From: John Wilkins
Sent: Monday, February 25, 2019 5:03 PM
To: James K. Scholl <jscholl@cityofkeywest-fl.gov>; Greg Veliz <gveliz@cityofkeywest-fl.gov>
Cc: Vanessa T. Sellers <vsellers@cityofkeywest-fl.gov>; Patrick Wright <pwright@cityofkeywest-fl.gov>
Subject: 1028 - 1030 Truman Ave.

I have visited this site to collect data and give my opinion concerning the impact of a new driveway to on-street parking for the proposed 1028 – 1030 Truman Ave. development.

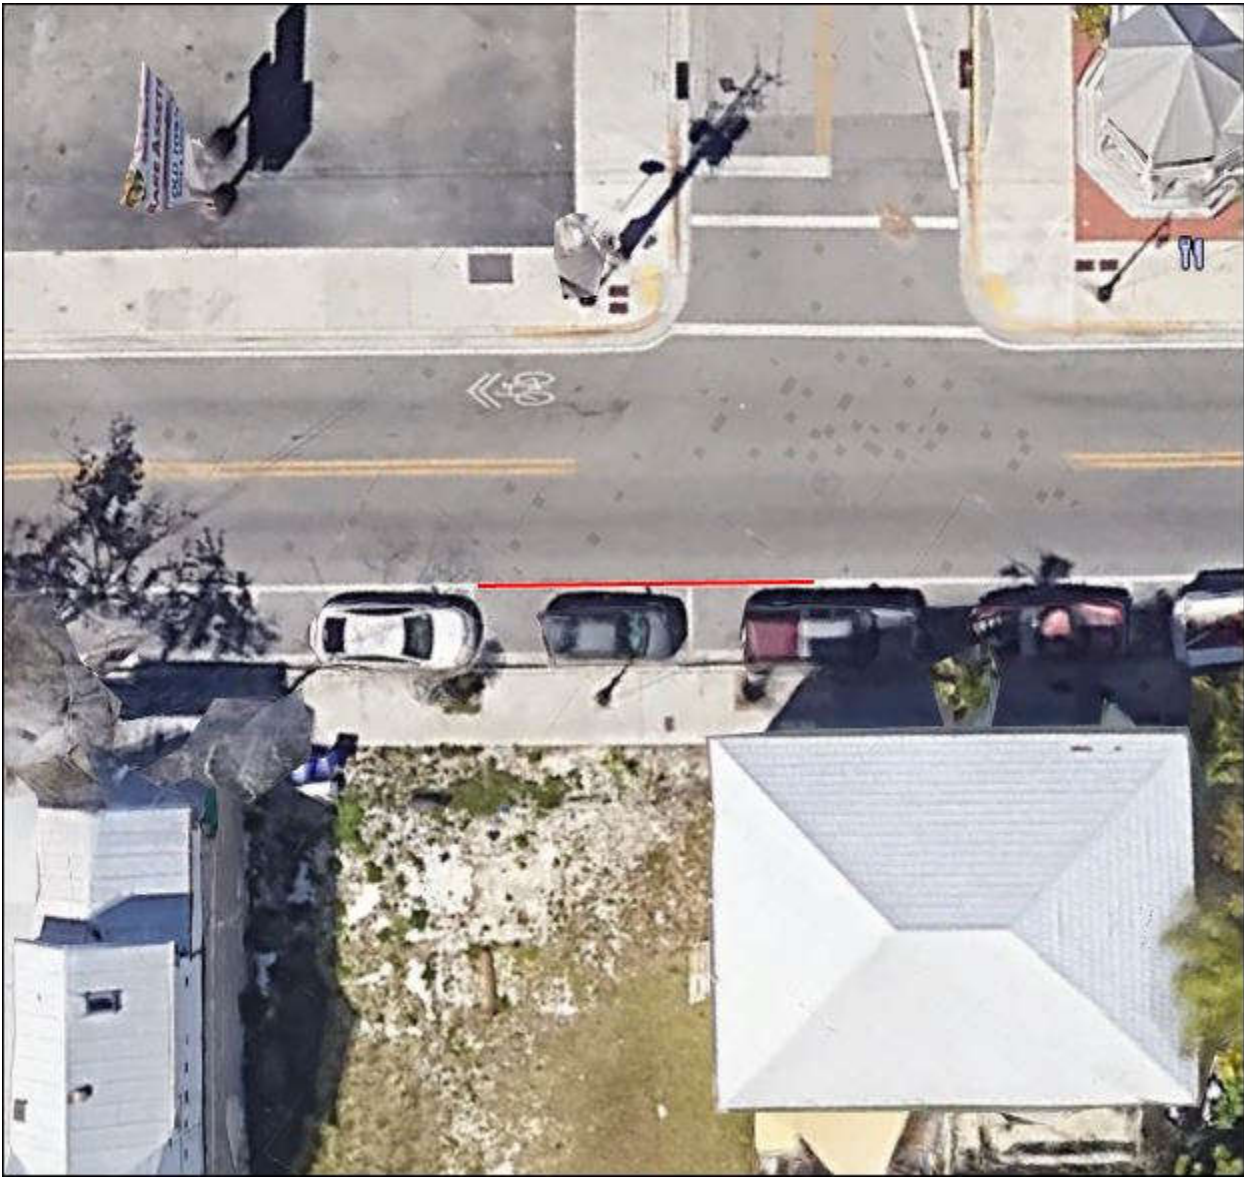
The no parking line-of-sight is calculated by traffic engineer based on traffic speed (85 percentile) at the location, width of sidewalk, location of vehicle driver, etc... In this block and next block, the existing minimum no parking line of sight is 18 feet (including 10 foot driveway flare). The maximum no parking line of sight in this area is 25 feet (including 10 foot driveway flare).

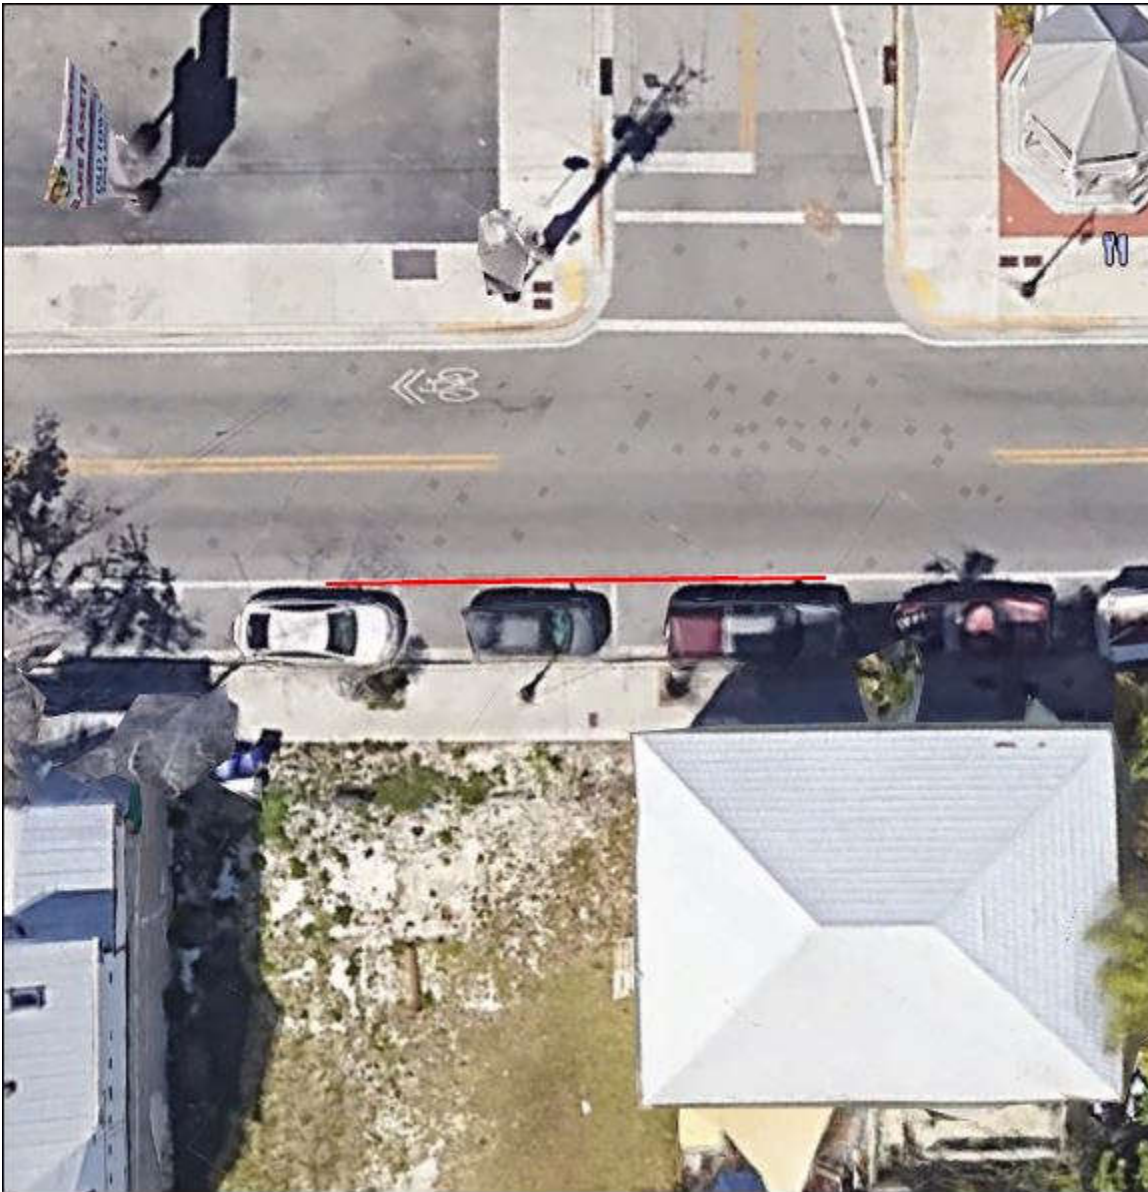
Two parking spaces would be lost on-street if the State only required the 10 foot flare for the no parking line of sight zone.

More likely, three spaces would be lost if they used the 18 feet minimum found in the area for the no parking line-of-sight zone.
